PRODUCT CHANGE | Drive Set for 35mm motor in 2.0" Ribbed Tube

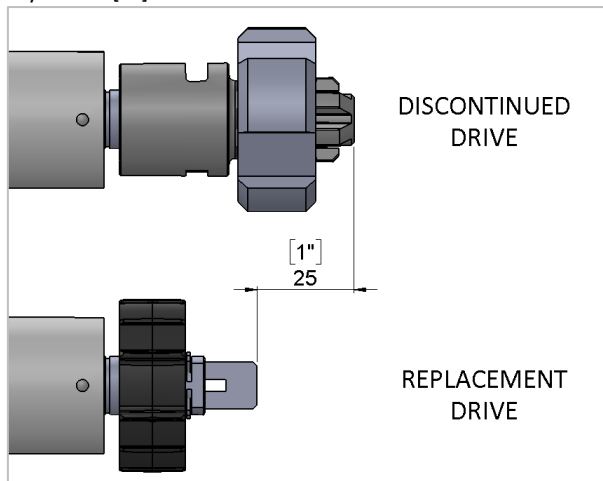
- Single piece drive design (reduced assembly time)
- Reduced minimum blind width by 25mm [1"]

- Soft outer body for silent operation
- Improved torque capacity
- Improved resistance to heat degradation
- Reduced cost
- Reduced minimum width
- Rubberized ribs grip tube for a better fit
